## Technical Comment

**File Reference:** APP-20181676

**Subject:** *Request for Technical Comment*

### Borelog for well E44/0623

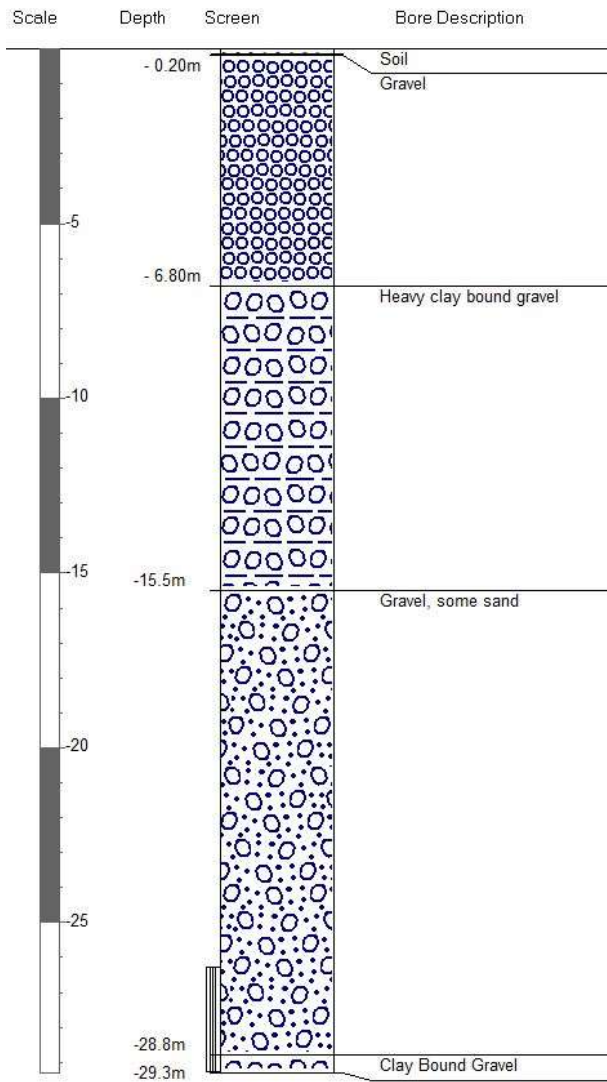
The existing take under AUTH-204993 from E44/0370 on the applicant's property is accounted in ES allocation records to be from Castlerock Groundwater Management Zone (GMZ), however, the depth, bore log, initial water level measurement (-4.68m in April, 2016) and location within the estimated extent of Lumsden aquifer all point to it being sourced from the Lumsden aquifer. The AEE for AUTH-204933 appears to make an assumption of an unconfined take without any supporting evidence, and this was not questioned in considering the application – perhaps due to the modest size of the take (43,800m<sup>3</sup>/year). It is worth considering, however, that a recommendation will be forthcoming to add this take to the current Lumsden aquifer allocation. Borelogs of E44/0623, used for irrigation under AUTH-20171076 and sourced in Lumsden aquifer, and E44/0370 are shown in Figure 1 below.
